Technical Bulletin
No: 127 – Instructions for Modifying console meter strap
from Hoyt to Modutec Meters

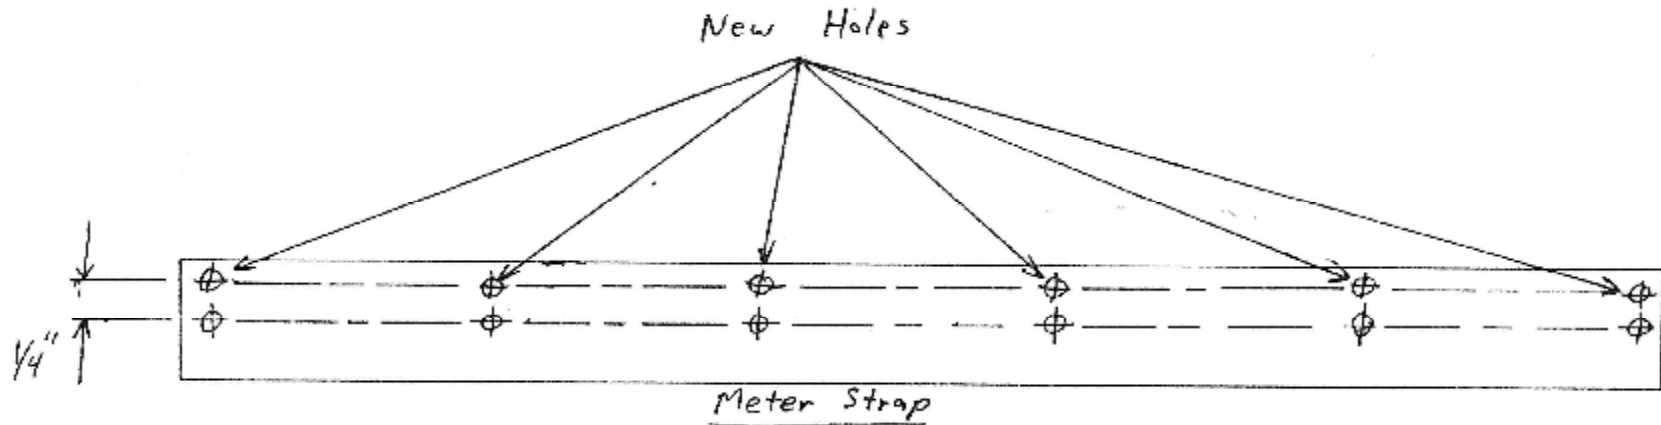
To modify RS console Hoyt meter strap for Modutec meters
drill a new 5/32" hole 1/4" above the center of all existing holes
